City of Richmond

Report to Committee

**To:** Planning Committee  
**From:** Joe Erceg  
Manager, Development Applications  
**Date:** December 19, 2002  
**File:** RZ 02-215547  
**Re:** **APPLICATION BY DAVA DEVELOPMENTS LTD. FOR REZONING AT 7071 NO. 4 ROAD AND 7060 BRIDGE STREET FROM SINGLE-FAMILY HOUSING DISTRICT, SUBDIVISION AREA F (R1/F) TO TOWNHOUSE DISTRICT (R2)**

CONCEPTUAL LANDSCAPE PLAN  
 7060 BRIDGE STREET, RICHMOND

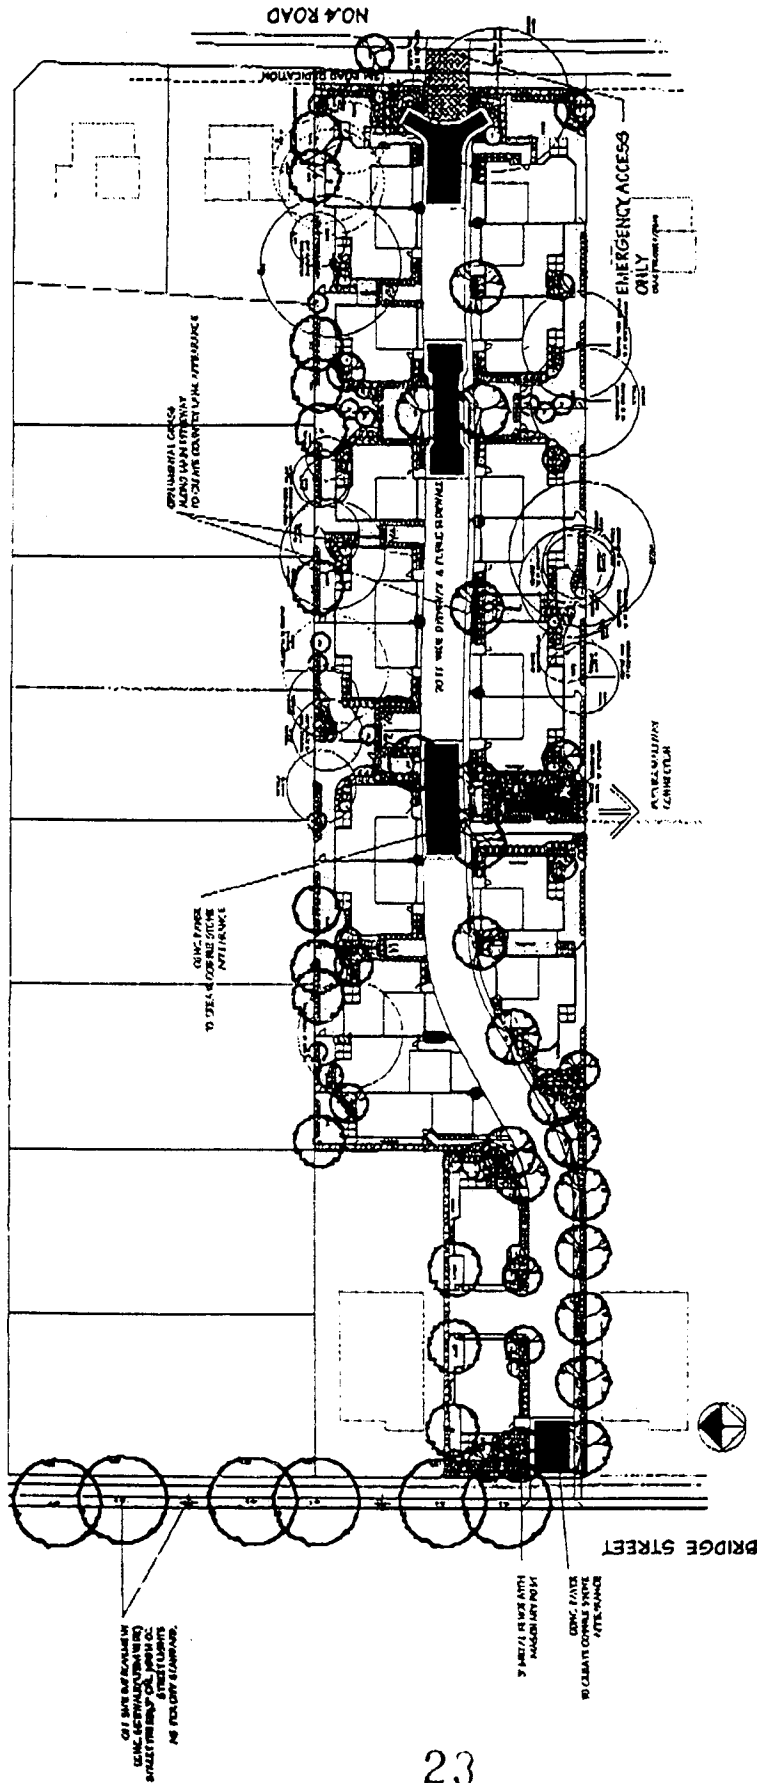
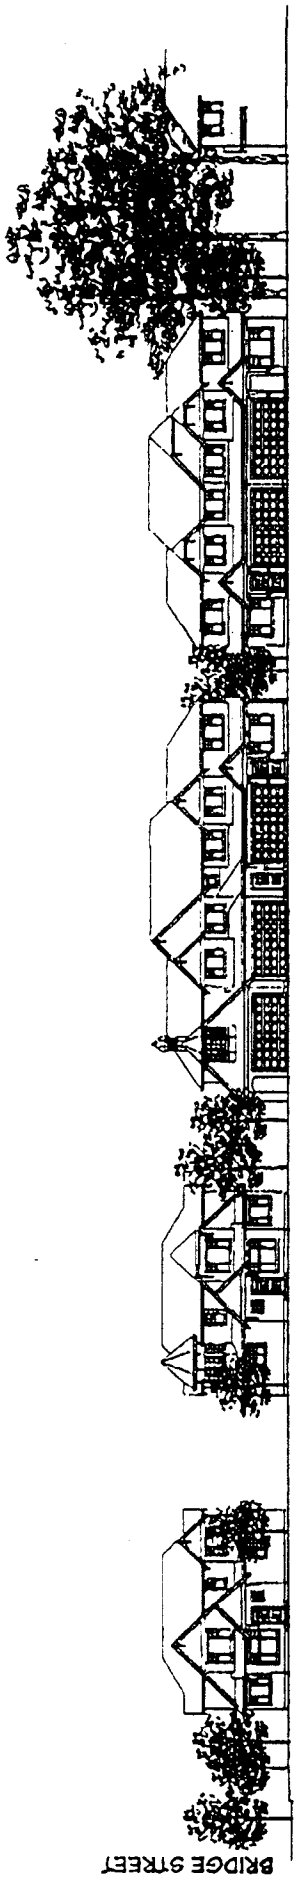
- The developer should work to better define the project's unit clusters by varying setbacks between buildings to create more space between the clusters, applying the concept/image of a "primary building" as described in the DP guidelines, incorporating distinguishable differences in the form and character of the various clusters, and reinforcing the definition of clusters through landscaping.

- The project, though required to only set back 6 m (19.7 ft.) from No. 4 Road under R2, should provide a more generous and varied setback along that edge, together with landscape features in keeping with the objectives of the sub-area plan.

- The project should seek to minimize overlook of the single-family lots north of the subject site by providing significant tree planting and landscaping along the site's north property line, limiting north-facing, second floor windows in the units along the north side of the site, and maximizing the size and landscaping of gaps between the unit clusters along that edge.

- The number of garage doors lining the project's driveway should be reduced by introducing a short north-south driveway between the two westernmost units and re-orienting their garages accordingly. This driveway should also provide vehicular access to future small-lot redevelopment at 7038 Bridge; however, as the home on that lot is relatively new, no redevelopment is expected in the short term.

- While the project's lot coverage is less than 40%, much of the site's open area is driveway, which leaves little opportunity for usable, common open space. Steps should be taken to increase the amount of common open space and to ensure that the project gives the impression of character homes set in a green landscape (rather than one of uniform housing units, garages doors, and unconnected patches of open space). Importantly, effort should be made in the design of the project's driveway to give the feeling of a "country lane". Measures to consider include lining the south edge of the site at the entry drive with a row of large, fast growing trees and a dense hedgerow reminiscent of the area's rural past; focussing the site's entry on a landscaped open space; gently meandering the alignment of the driveway; retaining/relocating mature trees along the driveway edge; clustering trees close to and overhanging the driveway; keeping the pavement narrow and edging it with grass and informal, indigenous planting; incorporating special pavement treatments; providing variety in the massing and design of the units; emphasizing unit entries and associated weather protection, gates, etc.; and, sensitively treating and orientating garage doors to diminish their impact on the internal "lane-scape".
